Errata

Use of Differential Pressure Feedback in an Automatic Flight Control System

David W. Levy and Jan Roskam
University of Kansas, Lawrence, Kansas
 [J. Guidance, 7, 250-251 (1984)]

Fig. 2 System flow diagram.

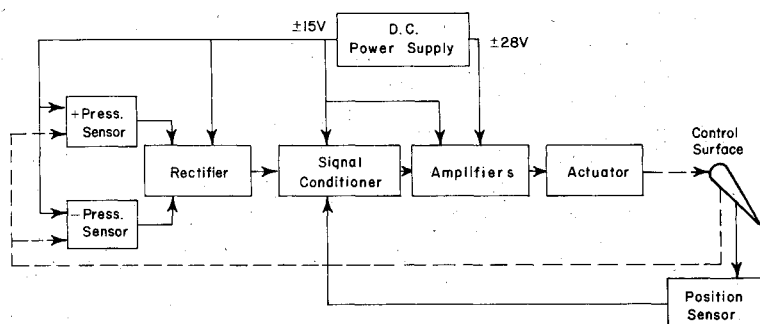
Captions for Figs. 2 and 4 were inadvertently reversed in printing. These figures should appear as follows:
